**BOARD OF ADJUSTMENT
CASE REPORT**

Case Number: **BOA-23078**

ACTION REQUESTED: Special Exception to increase the permitted driveway width (Sec. 55.090-F)

ZONING CLEARANCE PLAN REVIEW

PROJECT: DRAWN BY: CHECKED BY: DATE: SHEET: 1 OF 1	SABINO GUTIERREZ 13642 E. 28TH PLACE	PO BOX 887, SKIATOOK, OK 74070 (918) 638-4206 BY: _____ DATE: _____ _____ _____	
	SITE PLAN

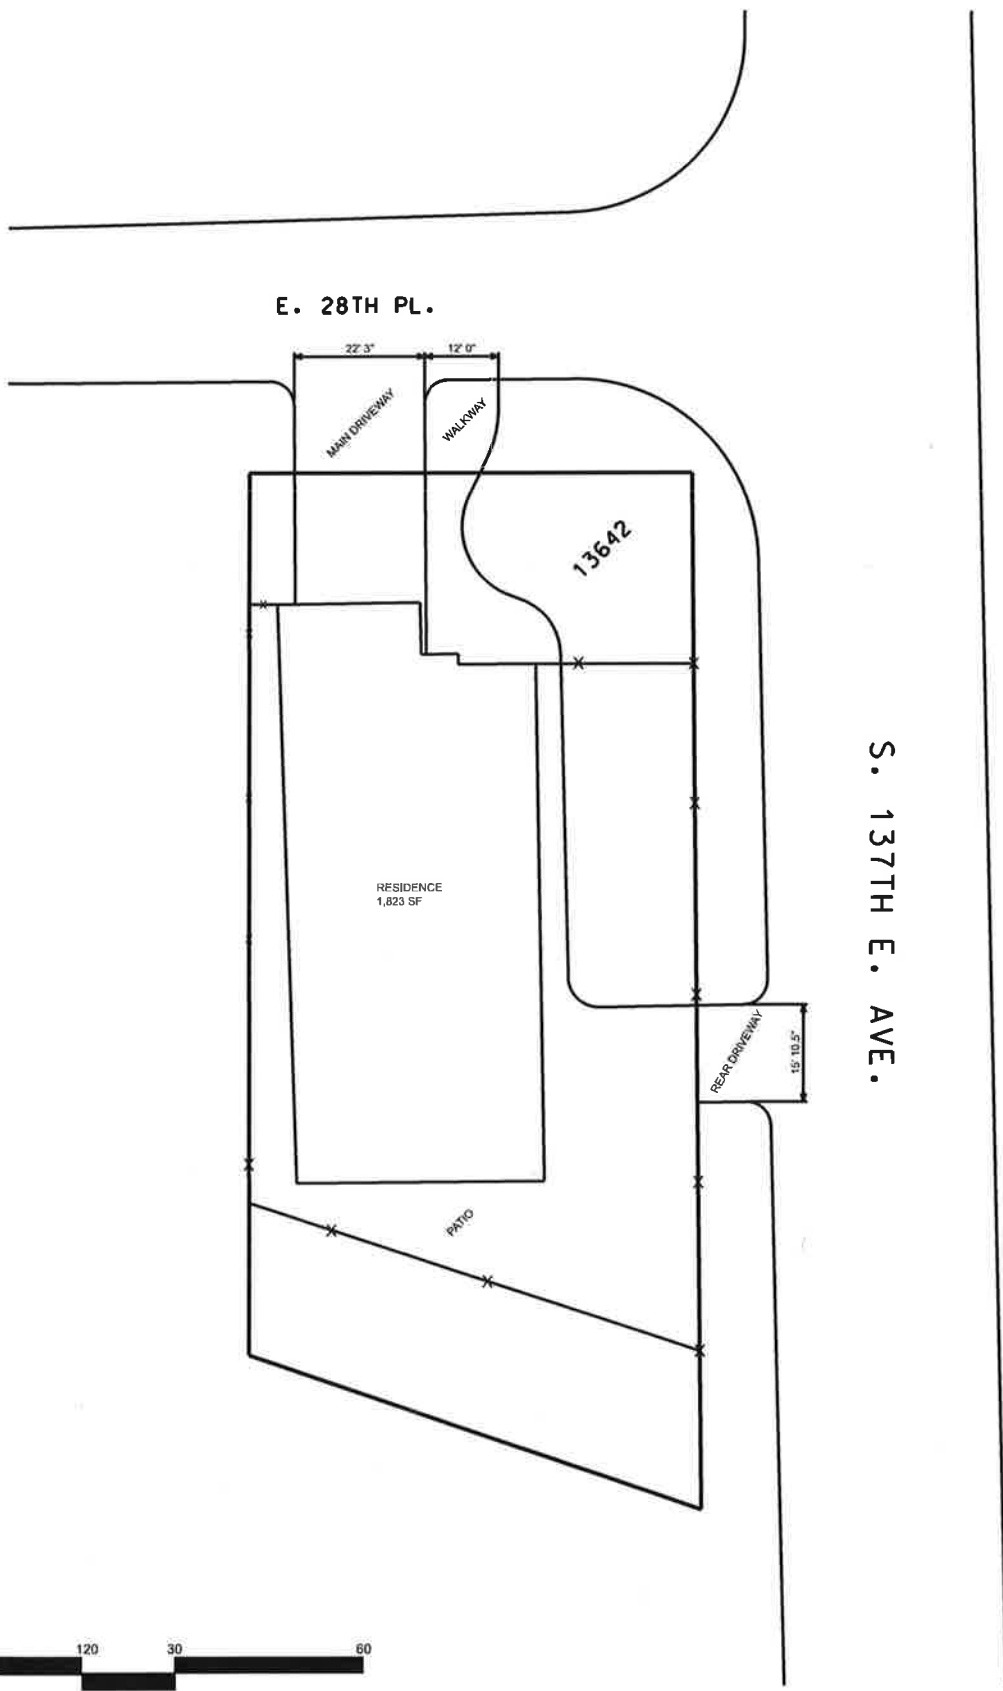
55.090-F3 Surfacing. In RE and RS zoning districts, driveways serving residential dwelling units may not exceed the following maximum widths unless a greater width is approved in accordance with the special exception procedures of Section 70.120. Based on your lot width the Maximum Driveway Width allowed in the Right Of Way (ROW) is 26' and 30' outside of ROW on this lot.

Review Comments: The submitted site plan proposes a combined driveway width of more than 30' in width on the lot in the street setback and more than 26' wide in ROW which exceeds the maximum allowable driveway widths both within and outside of the ROW. Revise plans to indicate the combined driveway widths shall not exceed the maximum allowable widths or apply to the BOA for a special exception, one for the proposed combined driveway widths within the ROW and also for the proposed combined driveway widths outside of the ROW.
